Teen Age Modern Fashion Ltd Matri Ghor Ltd

Aajan Tower, Purbahati, Hemayetpur, Savar, Dhaka

3rd March 2015

Typical layout plan

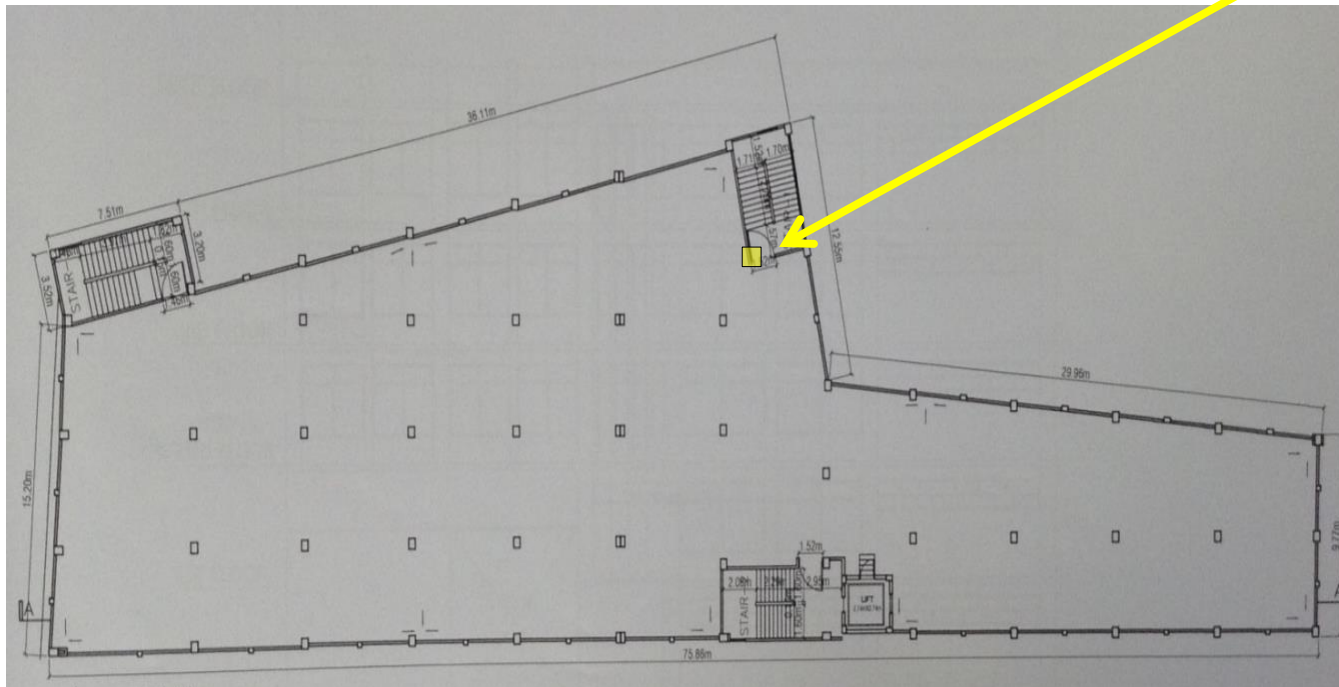
Heavily-loaded lift roof slab and additional lift room

- The lift plant room is situated on the top of the lift.
- The heavy lift machinery is sitting on the slab without connections to the main vertical load bearing structure.
- The slab is also weakened by many openings.
- Large brick aggregate was noted.

Item No.	Observation	Recommended Action Plan	Recommended Timeline
1	Heavily-loaded lift roof slab and additional lift room	Before the commissioning of the lift, Building Engineer to assess the capacity of the slab, the design loading of the lift and incorporate the existing openings in the design of the lift slab and load transfer system.	6-months
2	Heavily-loaded lift roof slab and additional lift room	Carry out any necessary structural works arising from assessment	6-months
3	Discrepancies between drawings and on-site observations	Building engineer to survey the as-constructed building.	6-months
4	Discrepancies between drawings and on-site observations	Updated drawings to be prepared showing the accurate as-built layout.	6-months
5	Discrepancies between drawings and on-site observations	The column not currently shown on drawings is to be included and its characteristics verified.	6-months

Expansion joint at Ground floor level

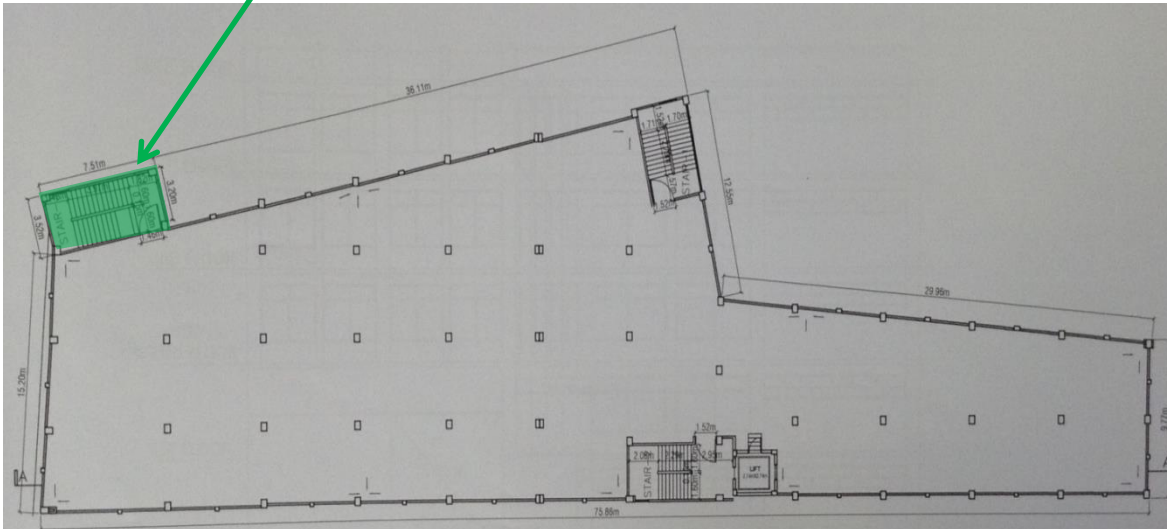
Poorly-constructed expansion joint at ground floor level

It appears that the expansion joint is connected at this level, which is possibly the reason that there are a lot of small cracks in the elements around the joint.

Item No.	Observation	Recommended Action Plan	Recommended Timeline
6	Poorly-constructed expansion joint at ground floor level	Building Engineer to investigate top of column and beam connections in the zone of the expansion joint at the soffit of the 1st floor, as well as the materials used in the joint.	6-weeks
7	Poorly-constructed expansion joint at ground floor level	Building Engineer to assess the design and detailing of the expansion joint.	6-weeks
8	Poorly-constructed expansion joint at ground floor level	Carry out any remedial structural and finishing works to the expansion joint, including any measures required at roof level to ensure the joint is watertight.	6-months
9	Apparently non-engineered escape stair core	Before the escape stair core is opened for use, Building Engineer to check its load bearing capacity, its lateral stability and its connection to the main building.	6-months
10	Apparently non-engineered escape stair core	Stair core to be included as part of the as-built drawings (see Item 2).	6-months
